LOCUST HILL CITIZENS' ASSOCIATION

July 26, 2012

The purpose of this letter is to request, on behalf of the Locust Hill Citizens' Association ("LHCA"), that you confirm the scope of the cost-benefit and design analysis that the State Highway Administration ("SHA") will undertake prior to submission of its request for funding of Phase 4 of the Cedar Lane-Rockville Pike intersection improvement project, as noted by County Executive Leggett in his July 12, 2012 letter to the Office of Economic Adjustment ("OEA").

**SHA CEDAR LANE PROJECT MAP
SHOWING ILLUSTRATIVE ALTERNATE PHASE 4 LANE
LOCATIONS**

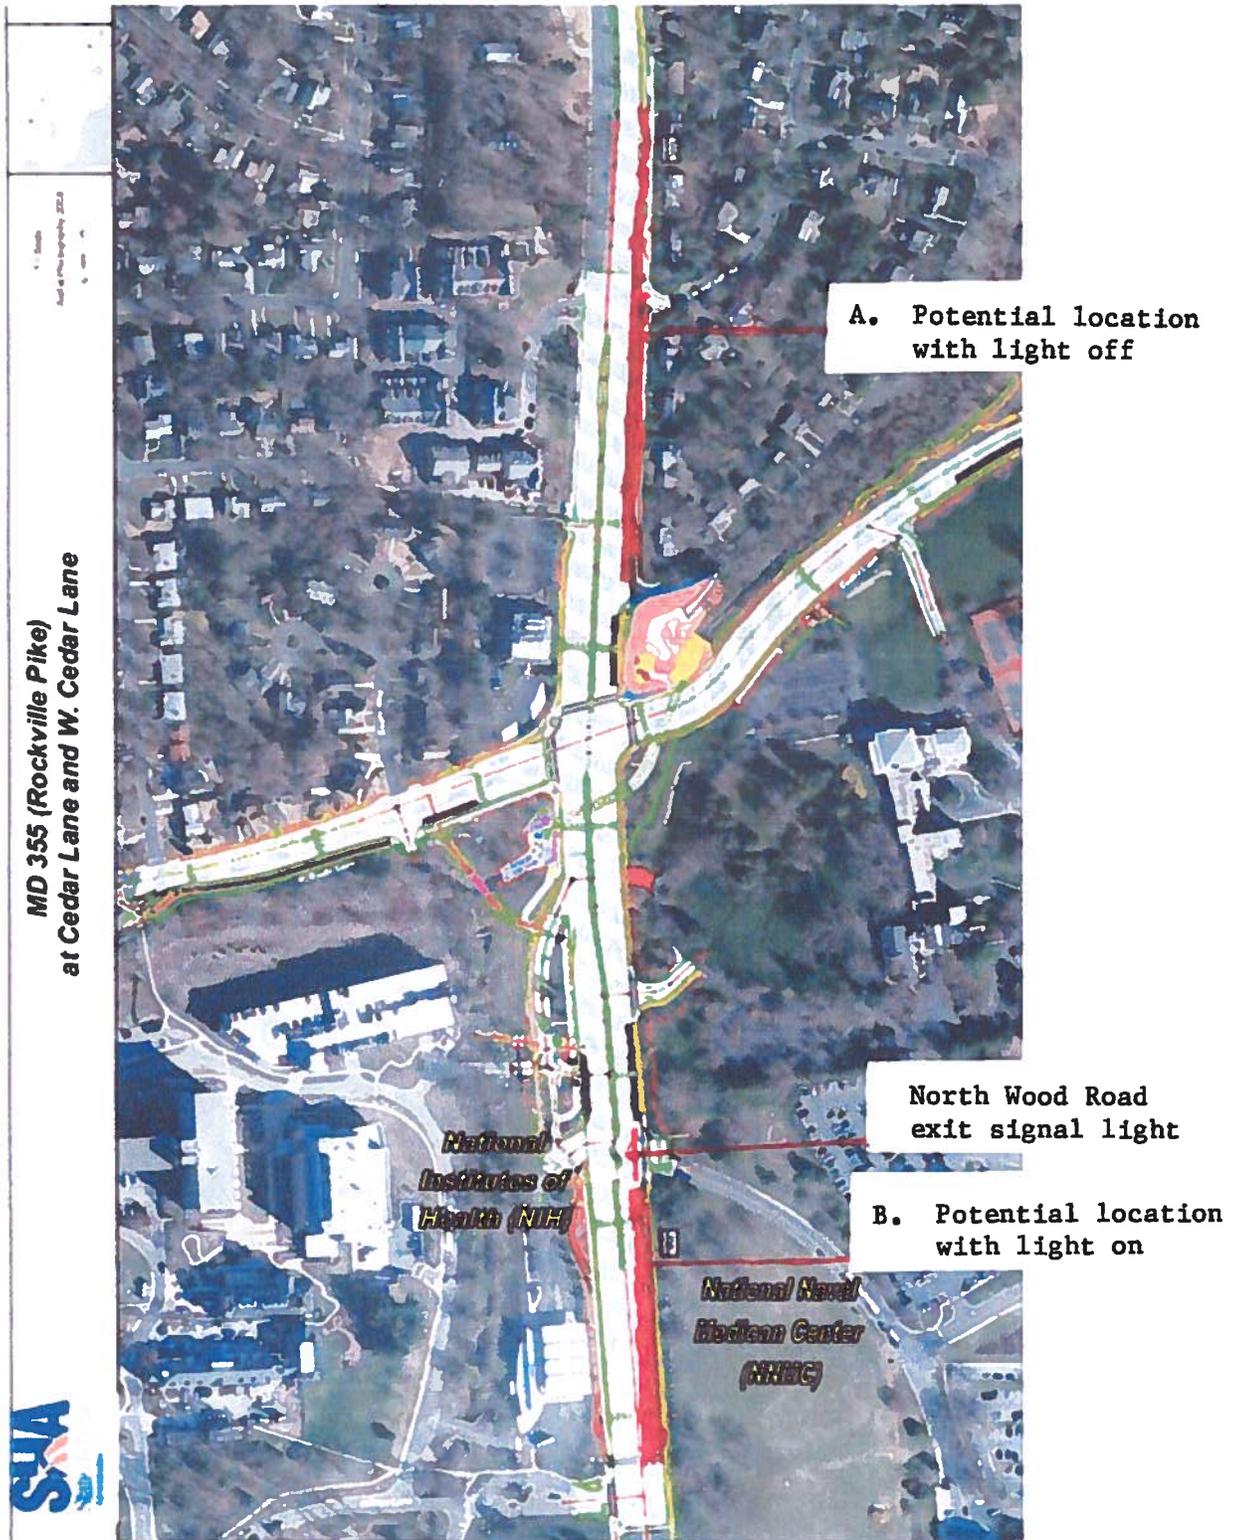
However, LHCA continues to believe that the construction of the auxiliary through lane would be unsafe and an inefficient use of federal traffic mitigation funds. In this regard, LHCA believes that SHA's additional cost-benefit analysis and design efforts would be incomplete unless SHA evaluates the auxiliary through lane's costs and benefits under scenarios that include possibility that the "temporary" North Wood Road exit signal would need to remain in service beyond the completion of the BRAC Cedar Lane projects.

northbound traffic turning right onto Cedar Lane was higher than previously estimated. As explained by Mr. Cutro, the resulting "weave conflict" above North Wood Road between this right-turning traffic and traffic departing Walter Reed using the North Wood Road gate—both of which traffic streams would use the same new lane under current plans—could well preclude the new lane's operation from being effectively or safely sustainable. Avoidance of such a result could necessitate having more than one lane for exiting traffic, which would require keeping the exit traffic signal at North Wood Road operational, making such an outcome a more probable result of the scheduled 2015 assessment of the exit signal's future.

In turn, as you confirmed in your June 20 email to us, continued operation of the exit signal would result in the auxiliary through lane having "minimal" traffic mitigation benefits, with the result that the auxiliary through lane would likely not be constructed. Consequently, SHA's analysis of Phase 4 and its design would appear inadequate if it does not consider the implications of the continued use of the exit signal on mitigation funds currently allocated to construction of the auxiliary through lane. For example, as noted by Mr. Cutro, constructing additional capacity between Wilson Drive and North Wood Road could permit northbound Rockville Pike traffic to flow more efficiently through and beyond North Wood Road if the signal light remains on.

Evaluating the relative costs and benefits of adding lane capacity through the North Wood Road intersection (or other traffic mitigation options) if the exit signal remains on would, of course, require further analysis—but that is just the point. We thus believe that SHA has an obligation to all stakeholders concerned with the mitigation of Walter Reed traffic to ensure that the analysis provided to OEA assesses the most appropriate use of Cedar Lane project funds within the project's boundaries if the exit signal should remain on—permitting Phase 4's locational details to be adjusted based on this engineering contingency. As an illustration, attached Exhibit 1 is a mark-up of the map used in SHA's October 2011 OEA submission showing the location of Phase 4's added lane capacity (if otherwise justified) in alternate locations based on the engineering contingency regarding the continued use of the North Wood Road exit signal.

In sum, we ask that you advise us of the scope of SHA's forthcoming Phase 4 cost-benefit and design analyses (including date of the traffic count data on which it will be based) and confirm that they will: (1) consider the possibility that the North Wood Road exit signal remains in use after the pending 2015 assessment; and (2) address a more appropriate location for Phase 4's lane capacity (if any), if additional analysis and/or a decision in favor of continued use of the exit signal demonstrate that the auxiliary through lane can no longer be viewed as a cost-effective and/or efficient means of achieving the Cedar Lane project's traffic mitigation objectives.
